CABINET MEMBER FOR HIGHWAY MANAGEMENT – 21 JULY 2022

GARSINGTON: WHEATLEY ROAD - PROPOSED ZEBRA CROSSING AND TRAFFIC CALMING BUILD OUTS

Report by Corporate Director, Environment and Place

C:\Users\raiph.green\OneDrive - Oxfordshire County Council\Schemes\145 Garsington - Various\Zebra Crossing - Various\Zebra Crossing\Wheatley Road Zebra Crossing.dwg

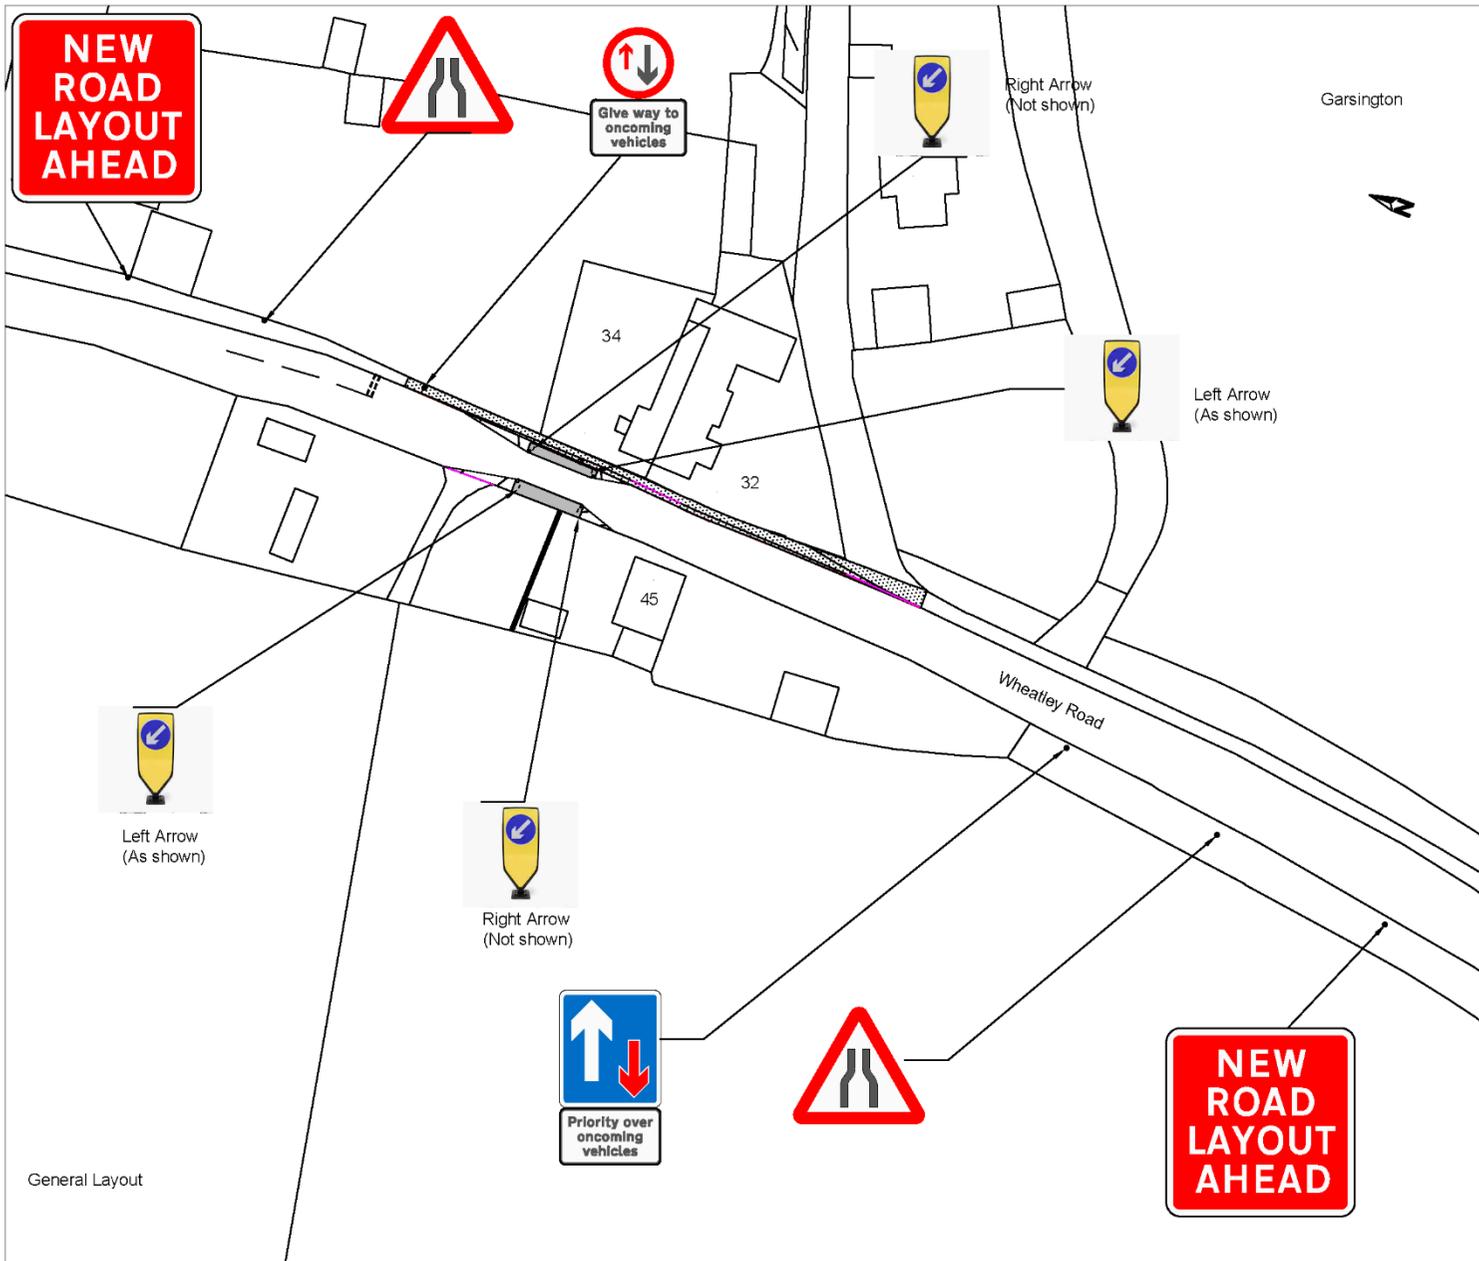
10. Thames Valley Police submitted no objection to the zebra crossing providing that the current speeds support such a crossing at this location, and that the proposed design meets latest design standards. They also raised concerns regarding the southern Wheatley Road proposals, citing that the priority would do nothing to slow traffic approaching the crossing, potentially causing traffic to queue within the controlled area and restrict visibility of pedestrians waiting to cross.

RESPONDENT	COMMENTS
<i>A. Zebra Crossing</i>	
(1) Traffic Management Officer, (Thames Valley Police)	No objection – Providing that speed data has been obtained and that current speeds support such a crossing at this location. And this design meets latest design standards .

(3) Member of public, (Garsington, Wheatley Road)	Concerns – I am in favour of the crossing. However, we already have our driveway blocked off from time to time by parents dropping pupils off at the school. This will get worse for us because of the extension of the yellow zigzags. It is a narrow road with unavoidable household parking on the school side of the road. Is it possible to restrict parking on the other side of the road , up to the North Manor junction during drop off times please?

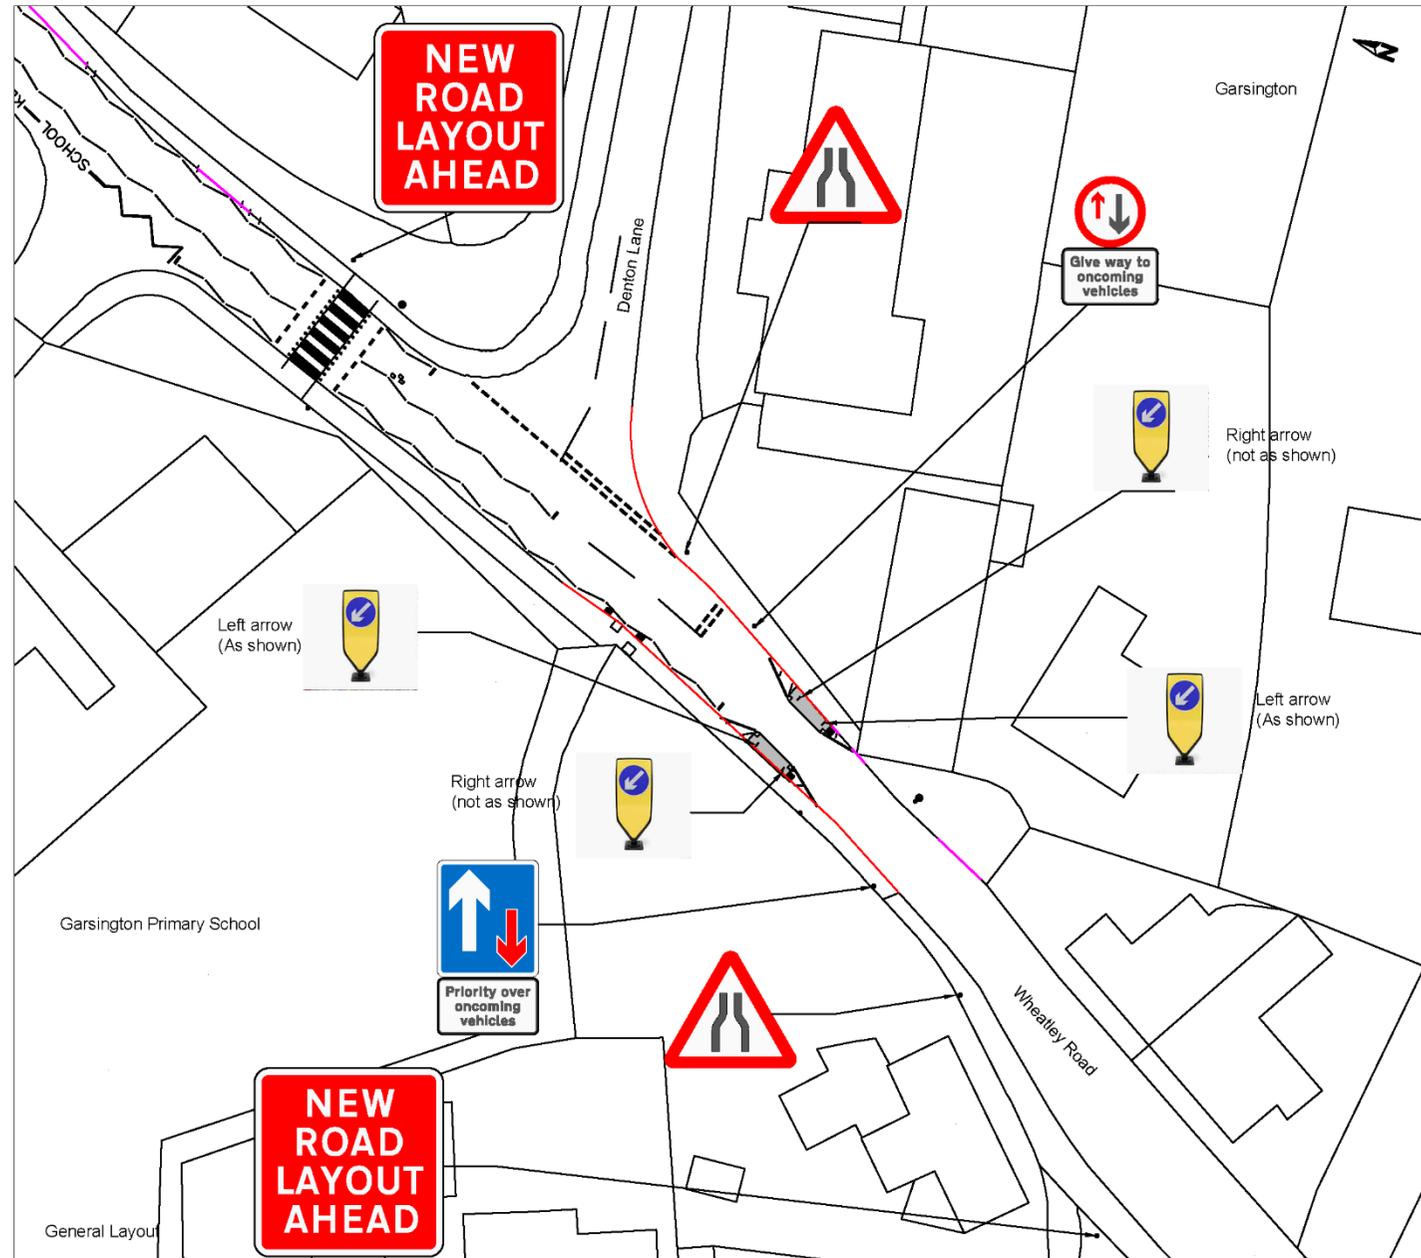
<i>B. Traffic Calming</i>	
(6) Traffic Management Officer, (Thames Valley Police)	<p>Concerns – I would further comment on the Wheatley Road south proposals .</p> <p>The priority does nothing to slow traffic approaching the crossing . It might cause queuing within the controlled area and restrict visibility of pedestrians waiting to cross. The priority Give way lines appear within the controlled area which I believe is not permissible. The School Keep Clear should be shortened and replaced with pedestrian crossing markings ,making parking illegal and enforceable.</p>

(7) Member of public, (Denton, Brookside)	<p>Object - As a resident of Denton, I regularly go through the junction of Denton Lane and Wheatley Road. I feel that both the South pinch point and proposed Zebra crossing are too close to the junction of Denton Lane. I feel this will make turning out of Denton Lane in either direction more hazardous for drivers and pedestrians alike. When turning left out of Denton Lane you will immediately be at the southern pinch point and as oncoming traffic has priority there will not be enough distance to check for oncoming traffic to see if it is clear to proceed. If turning right out of Fenton Lane a driver would immediately be at the Zebra Crossing meaning that pedestrians waiting to cross will have to check for cars turning out of Denton Lane as well as each way along the Wheatley road. The road doesn't offer great visibility to drivers as it is due to hills, corners and parked cars. In the other local places where these pinch points are located (Wheatley and Horspath) there is much more visibility of the road ahead for drivers to assess if the road ahead is clear and if it is save to pass. I would like to see the southern pinch point moved away from Denton Lane and the Zebra Crossing changed to a Pelican crossing so that it is clearer for drivers and safer for pedestrians to cross.</p>

(12) Member of public, (Garsington, The Hill)	<p>Concerns – I am very concerned about the traffic calming proposed in Garsington. The two kerb narrowing approx 168 metres is fine but the one 20 metres south is going to cause great problems for the people living at that part of the hill. I also think all the farm machinery we have going through would have a problem getting through the narrower road especially at harvest time.</p>
